PRODUCT CHANGE NOTIFICATION

Bourns® Model CDSOT23-SR208 Steering Diode Array and CDSOT23-SRV05-4 Steering Diode TVS Array Combo

Addition of Manufacturing Site

ESD2311REV

Typical Part Marking

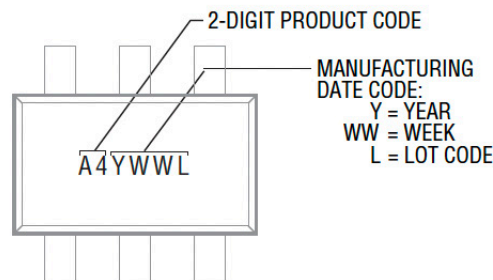
The Si fabrication ~~and the assembly~~ process will not change ~~at this new additional assembly and test manufacturing site~~. ~~The assembly process at the new site will change slightly because~~ the interconnect material used at this new site will be changed from gold to copper, ~~and the terminal finish will be changed from NiPdAu pre-plating to 100 % tin plating~~. These changes have been fully qualified and will have no impact on the fit or function of the affected part numbers. The part marking will be used to identify units produced at the new additional assembly and test manufacturing site. The lot code (L) of the new site will follow alphabetic characters while the current site will continue to use numbers.

The form of the part numbers made at the new additional manufacturing site will change ~~due to the material changes described above and~~ because of a small change in the part marking for traceability purposes. The quality, reliability and performance of the overvoltage protectors produced at the new manufacturing site will be the same as those from the existing plant. The production lead times of these overvoltage protectors should improve gradually as our capacity is expanded. The country of origin will remain the same.
